APPLICATION NO.	FILING DATE	FIRST NAMED INVENTOR	ATTORNEY DOCKET NO.	CONFIRMATION NO.
10/688,663	10/16/2003	Norman Shendon	770C6-099006	1195
7590	11/08/2004		EXAMINER	
			NGUYEN, GEORGE BINH MINH	
			ART UNIT	PAPER NUMBER
			3723	
DATE MAILED: 11/08/2004

Office Action Summary	Application No.	Applicant(s)	/
	10/688,663	SHENDON ET AL.	
	Examiner	Art Unit	
	George Nguyen	3723

DETAILED ACTION

0156746

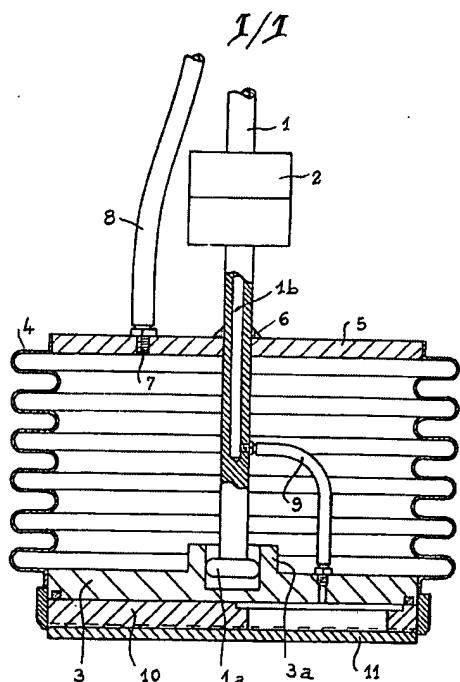
2. Claims 1, 4, 5, 7, 8, 10, 11, 15-18 are rejected under 35 U.S.C. 102(b) as being anticipated by EPO'156746.

With reference to Figure 1, EPO'746 discloses the claimed invention.

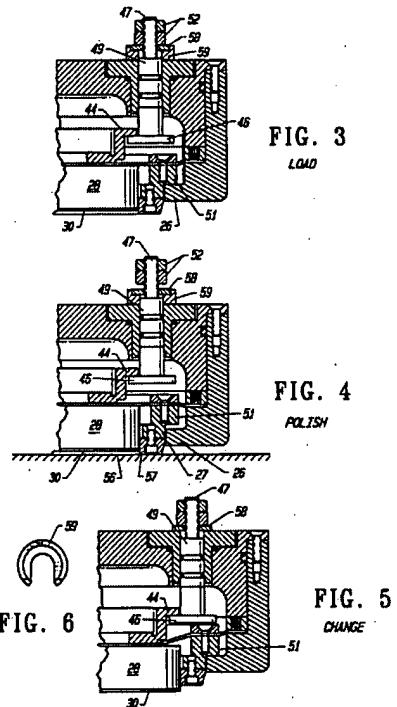
EPO'746 has been discussed above, but does not disclose a retainer ring independently movable relative to the backing member.

With reference to Figs. 3-5, col. 5, line 46 to col. 6, line 10, Shendon discloses a wafer polishing head that enables a wafer retainer to float during polishing and yet independently extends beyond the backing member 28 to control the movement of wafer during polishing or changing the wafer.

Please note that Shendon teaches a 1st chamber 23 between housing 12 and backing member 28. The 2nd chamber is the volume underneath membrane 29.

Thus, it would have been obvious to one having ordinary skill in the art at the time the invention was made to have modified the polishing apparatus of EPO'746 with a retainer ring and 1st chamber and 2nd chamber as taught by Shendon to control the movement of the wafer.

Fig. 3A

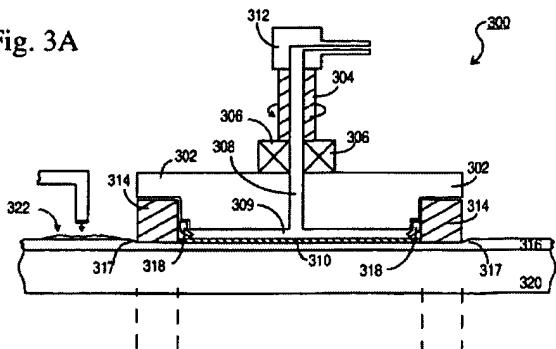
With reference to Fig. 3A, col. 4, line 25 to col. 5, line 25, Breivogel discloses the claimed invention.

Please note that the recess area 309 is the area created by lip seal 318 in combination with front surface of the backing area.

Thus, it would have been obvious to one having ordinary skill in the art at the time the invention was made to have modified the recess area of EPO'746 with the teaching of covering substantially the entire back surface of the substrate as taught by recess area 309 of Breivogel in order to provide a stronger holding force during polishing.
